Proposal #02: 1060-44-70, WISC 2015484
East West Freeway
CTH P to CTH F
ID 94
Waukesha County

This is Addendum No. 01, which provides for the following:

ADDENDUM NO. 01

Addendum No. 01
ID 1060-44-70
Revised Sheet 2
August 20, 2015

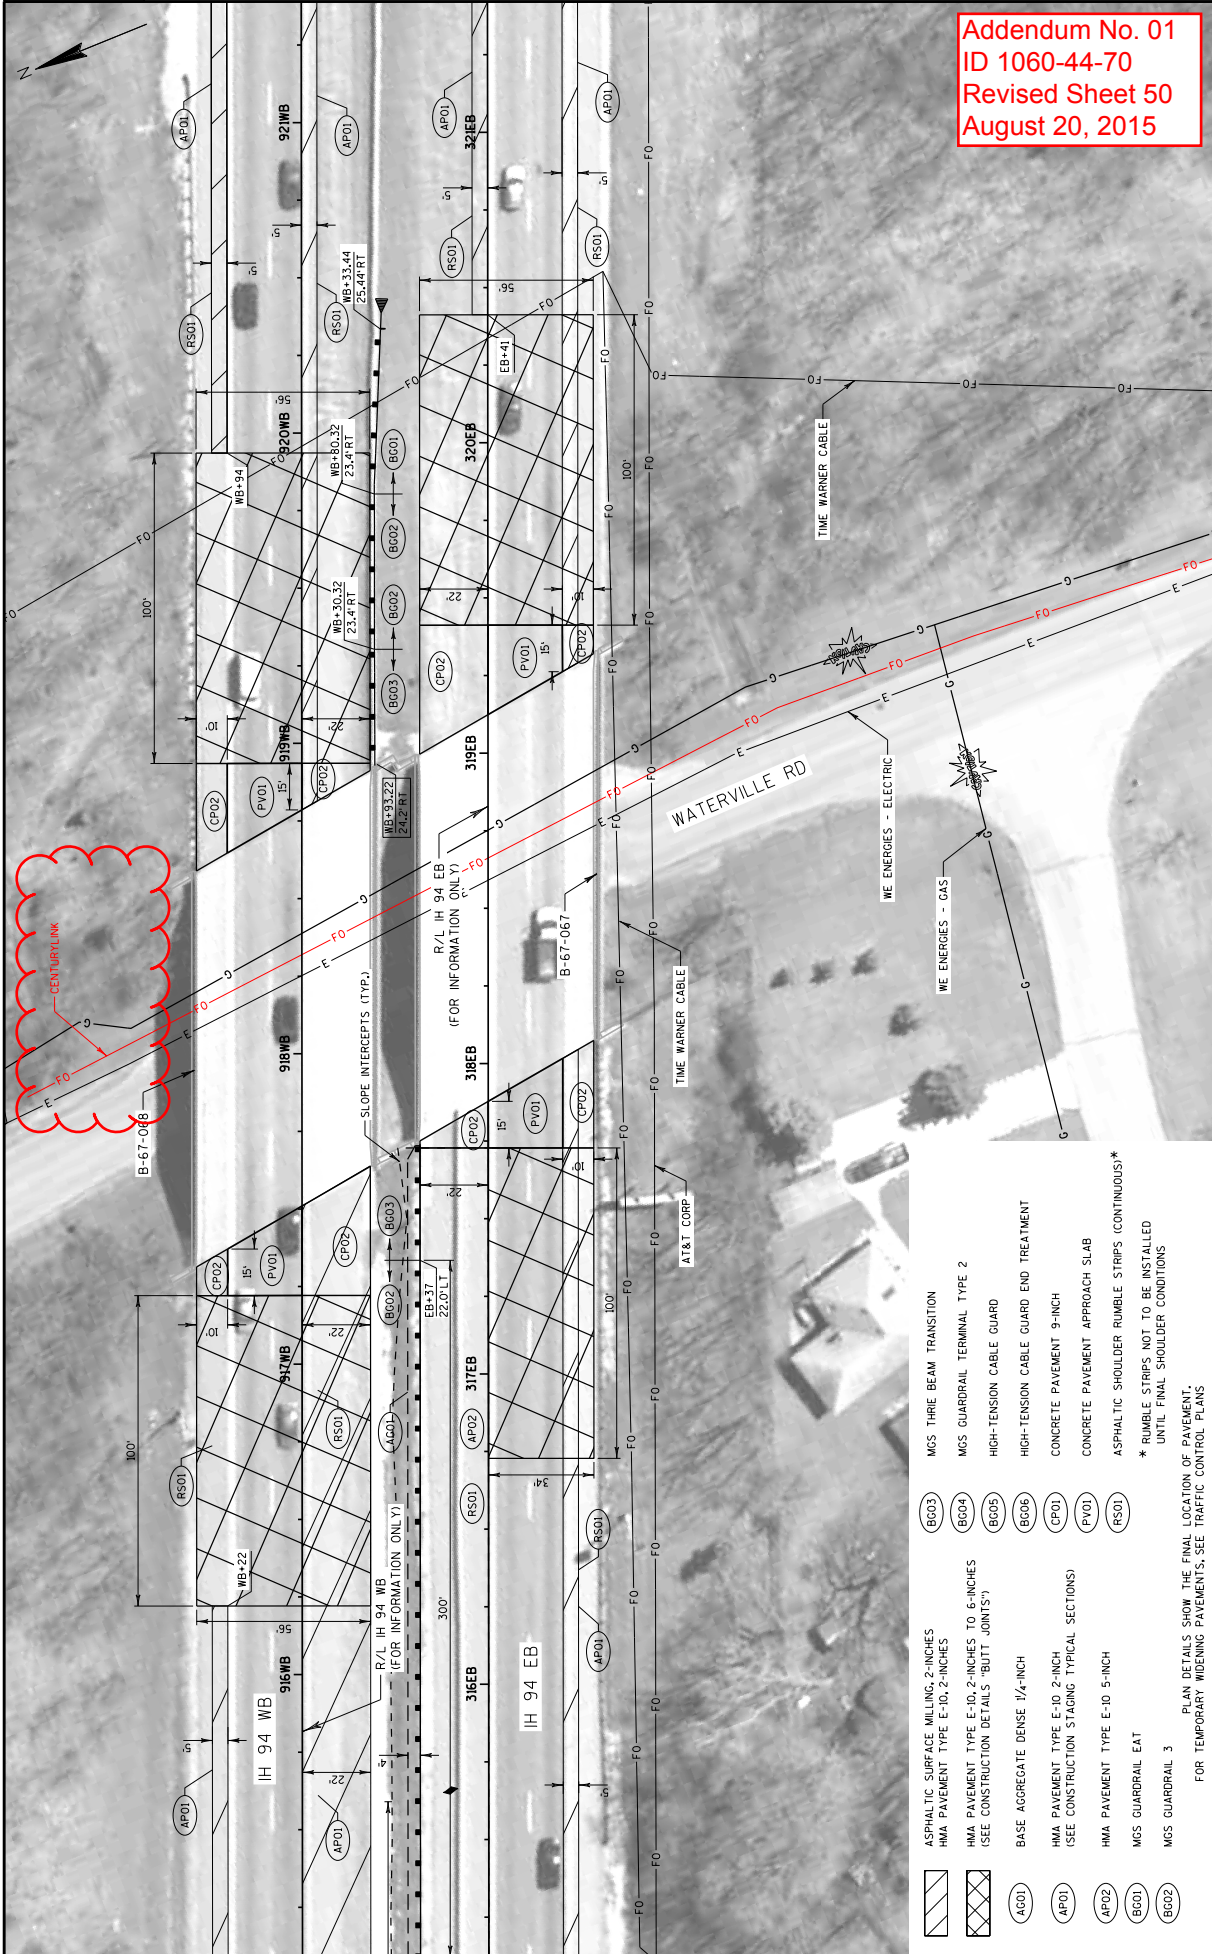
Revised Plan Sheets	
Plan Sheet	Plan Sheet Title (brief description of changes to sheet)
2	Updated utility contacts
50	Added Centurylink facilities
55	Added Centurylink facilities
61	Added Centurylink facilities
66	Added Centurylink facilities
421	Divided Common Excavation column two bid items, Common Excavation and EBS Excavation
433	Replaced Field Office Type D with SPV item for Field Office Fixed
